Town of Maynard

January 13, 2026 Planning Board Meeting

2. Public Hearing - 151 Main Street (Continued From December 9, 2025)

Peer Review Comment Form

SITE DEVELOPMENT PLAN
FOR: MATTHEW HALL
SCALE: 1"=20' OCTOBER 9, 2025
REVISED: DEC 4, 2025

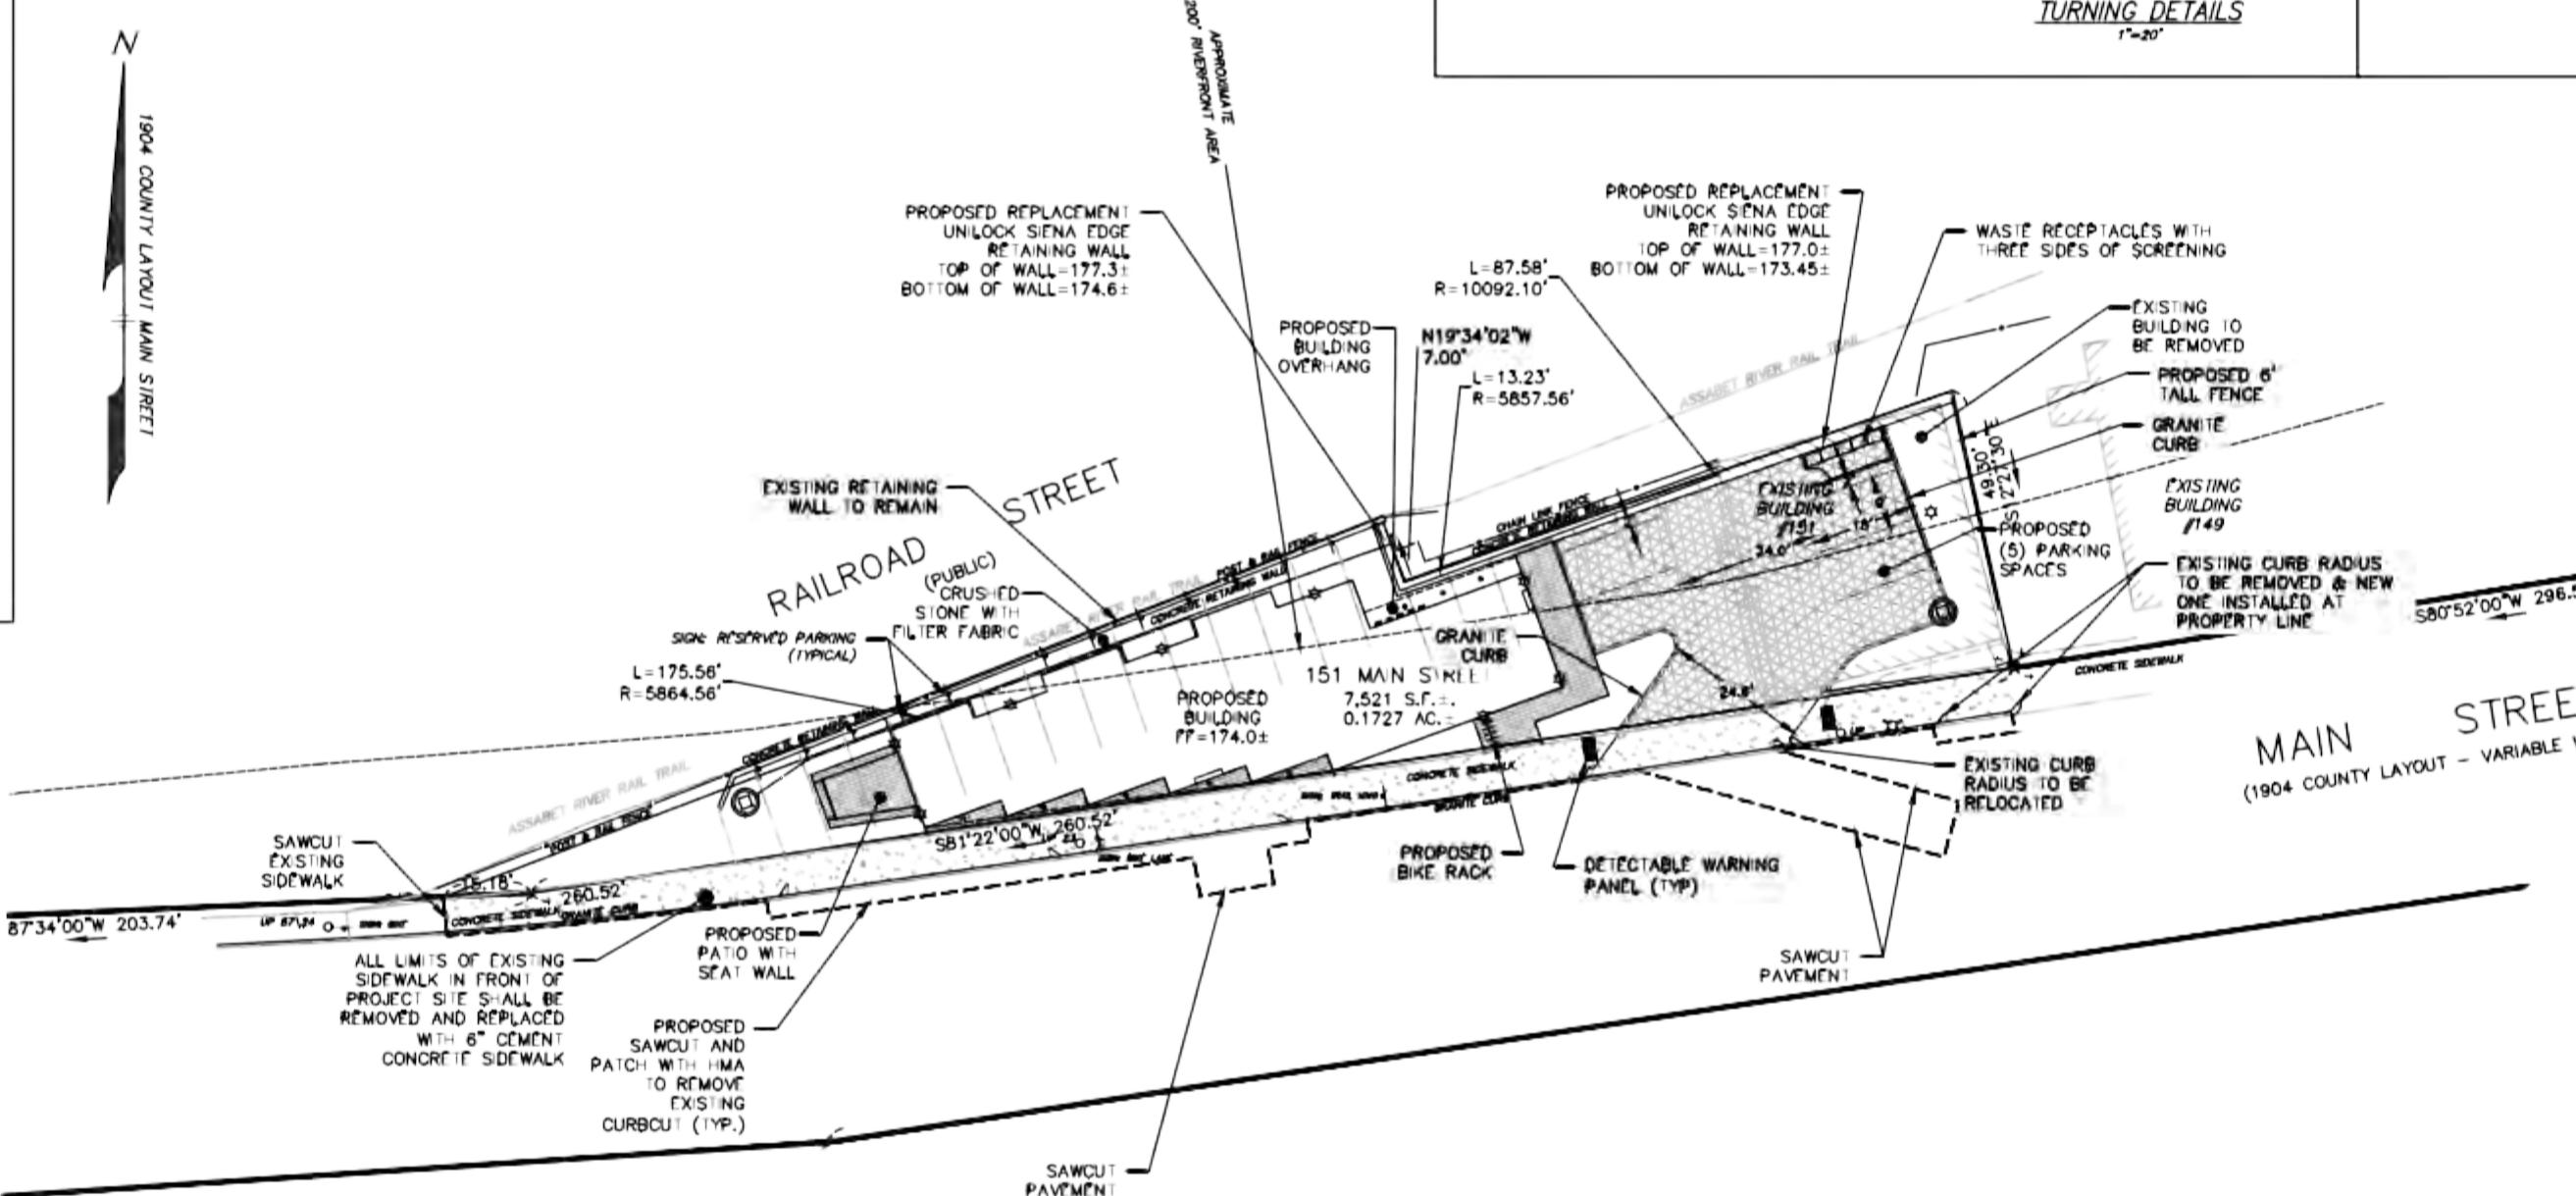
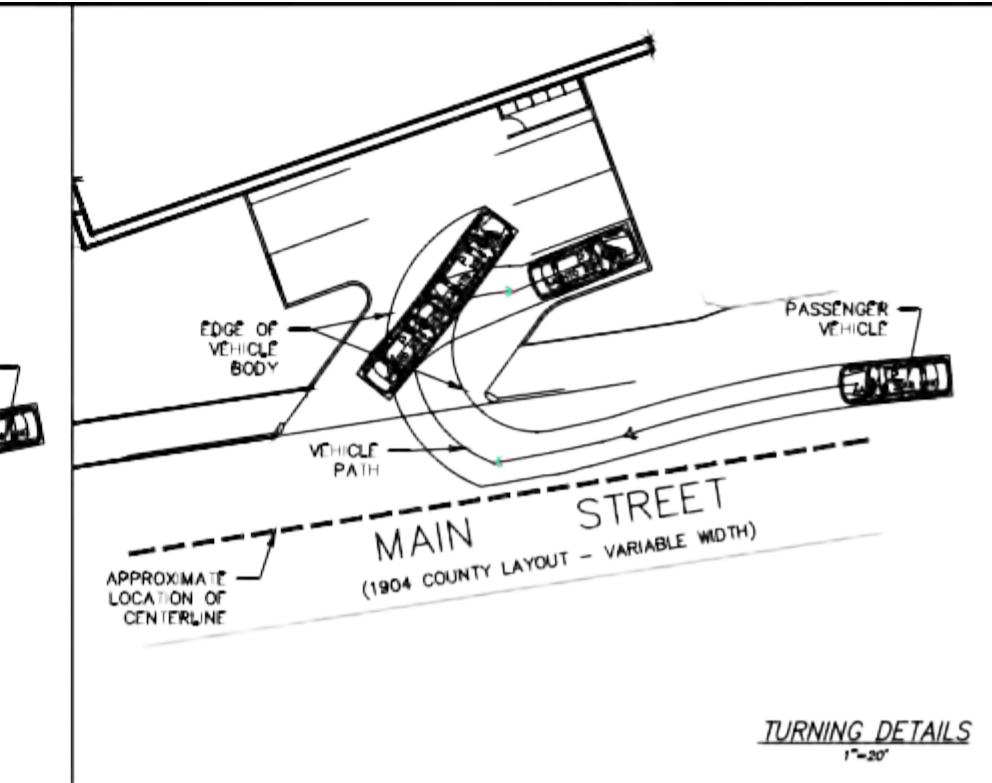
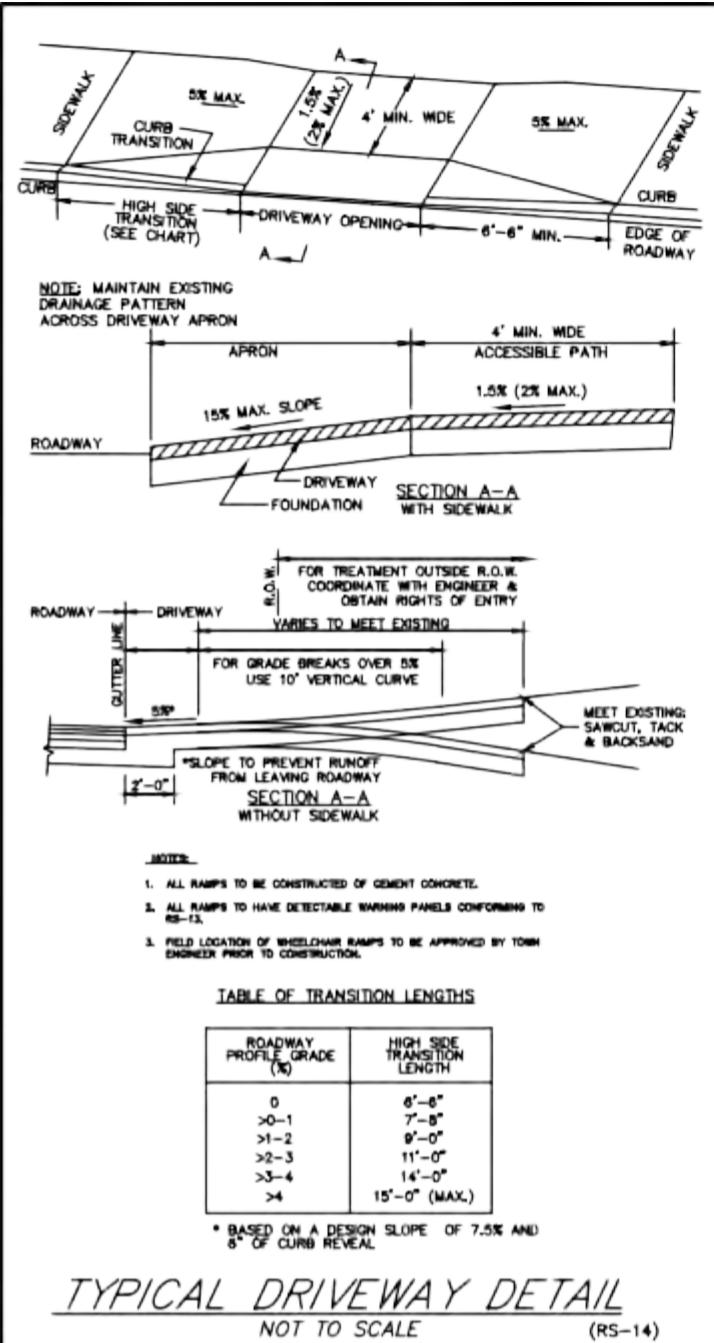
5	Site Development Plan		A cape cod berm and granite curb is proposed in the parking lot. A granite curb is recommended to hold up better against snow plows. Please consider revising.	All curbing is now proposed as granite.	VR	12/9/2025
6	Site Development Plan		It is recommended that the curb line on the eastern portion of the site moves the curb cut to the property line since the old curb cut for the garage door is no longer needed. Please consider revising.	The existing curb cut on the eastern portion of the site is now proposed to be moved to match the eastern edge of the frontage since there will be no garage there after this project is completed.	VR	12/9/2025
7	Site Development Plan		Is the existing wall being removed and replaced with a new wall or are the walls going to be next to each other? Any items to be removed should be called out on the plans. Proposed walls should be detailed on the plans with the existing walls if they are to remain. Please revise.	The rail trail retaining wall is to remain as is, and the other wall replaced with a unilock retaining wall. The labels for the walls have been updated.	JT	12/23/2025
